RESPONSE TO REQUEST FOR ADDITIONAL INFORMATION

APR1400 Design Certification

Docket No. 52-046

RAI No.: 274-8277
SRP Section: 07.01 - Instrumentation and Controls - Introduction
Application Section: Section 7.1, 7.3, and 10.2
Date of RAI Issue: 10/27/2015

Figure 7.3-23 Radiation Monitoring System Measurement Channel Functional Diagram

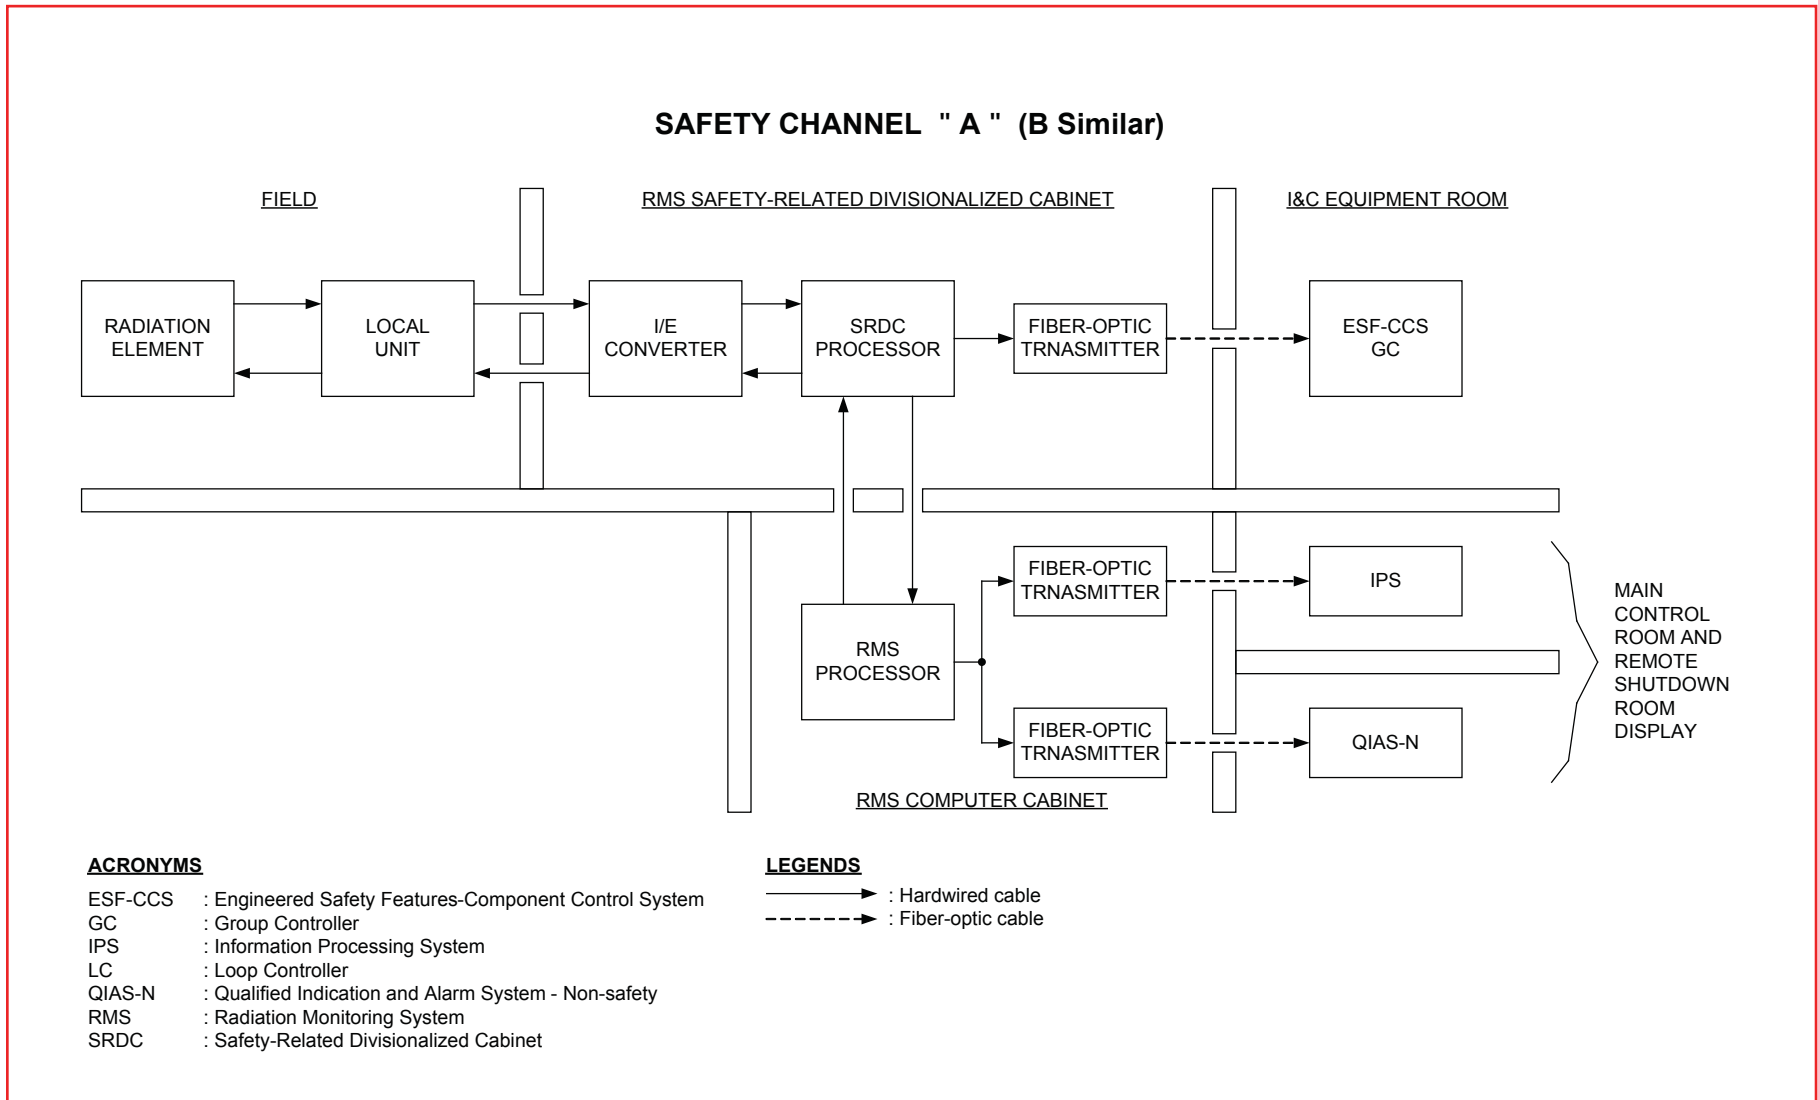
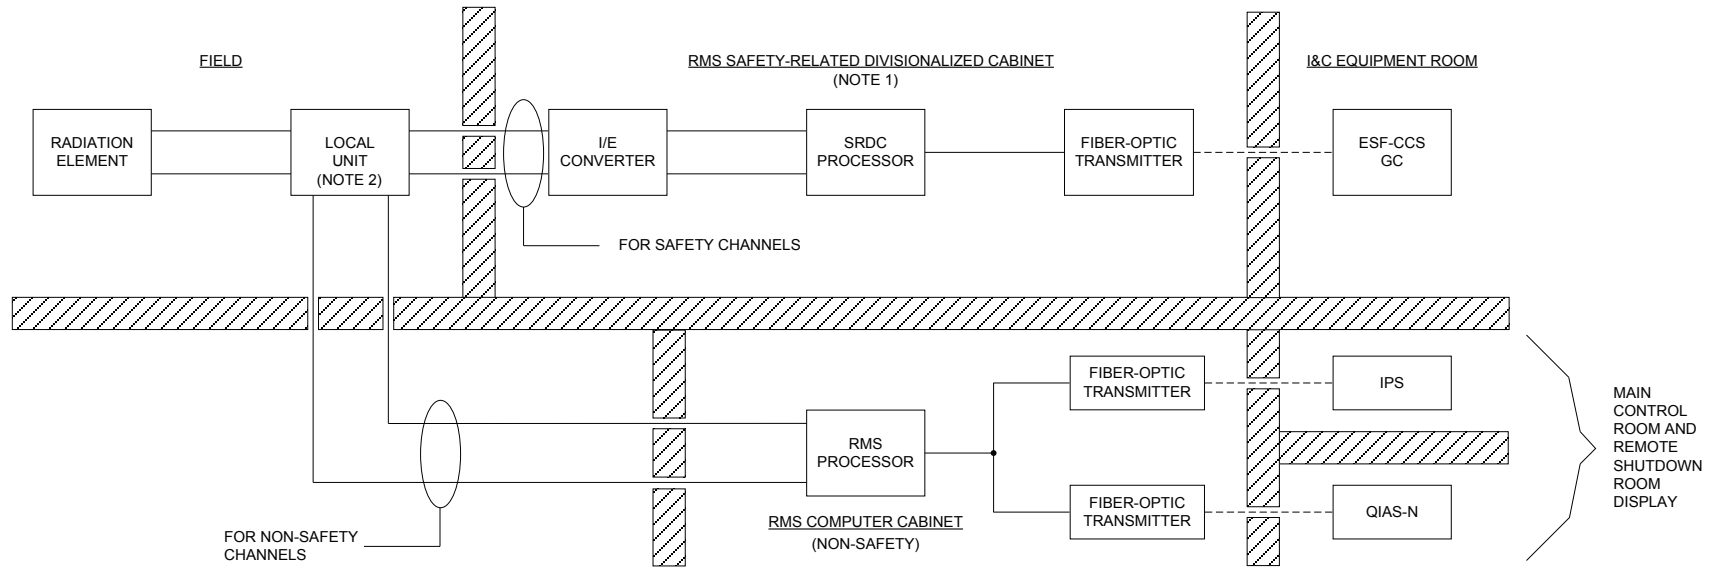
- a. APR1400 FSAR Tier 2, Section 7.3.1.1, states the balance of plant (BOP) ESFAS receives process variable signals from the safety portion of the RMS, manual ESF system-level actuation switches, and manual channel bypass switches. The BOP ESFAS consists of 1-out-of-2 logic taken twice except for the Fuel handling area emergency ventilation actuation signal (FHEVAS), which has one 1-out-of-2 logic. APR1400 FSAR Tier 2, Figure 7.3-23, shows the RMS measurement channel functional diagram, but design descriptions or reference to this figure were not provided in FSAR Tier 2, Section 7.3. Based on this figure, it is not clear how many divisions are in the RMS SRDC. In addition, it is not clear whether the RMS computer cabinet is safety-related or non-safety. If the RMS processor in the computer cabinet is non-safety, then how is it isolated from the SRDC processor to meet the independence requirements of IEEE Std. 603-1991, Clause 5.6.3? If the RMS processor is safety-related, how is it meeting independence requirements of IEEE Std. 603-1991, Clause 5.6.3 when transmitting information to the IPS and QIAS-N?

Figure 7.3-23 is to be revised to reflect the latest system functional configuration. The radiation monitoring system (RMS) processor receives the electrically isolated radioactivity measurement signal directly from the local unit, rather than from the safety related divisionalized cabinet (SRDC) processor.

The revised figure is a simplified block diagram which provides a functional overview of the RMS. Although the number of divisions for the SRDC can be inferred from the previous heading written above the SRDC, where it states "safety channel 'A' (B similar)," a note has been added to clearly state the SRDC cabinet has redundant

The RMS computer cabinet is non-safety related; Figure 7.3-23 is to be revised accordingly for clarity. Those measurement signals originating from the safety related detector channels that are transmitted to the non-safety RMS processor are electrically isolated using an IEEE Std 384 Class 1E qualified isolator per Clause 6.2.2, at each local unit. This satisfies the independence requirement between safety systems and other systems per IEEE Std 603-1991, Clause 5.6.3.

Since the isolation is done at the local unit, no isolation is needed for those signals sent to the IPS and QIAS-N. The revision to Figure 7.3-23 shows the connection from the RMS processor to the IPS and QIAS-N through a fiber-optic converter. The fiber-optic converter does not provide isolation, but provides data communication paths via fiber-optic signal transmission.

Replace this figure with attached figure A.

1. THE SRDC CABINET IS REDUNDANT, HAVING DIVISIONS A AND B.
2. ISOLATORS ARE INCLUDED.
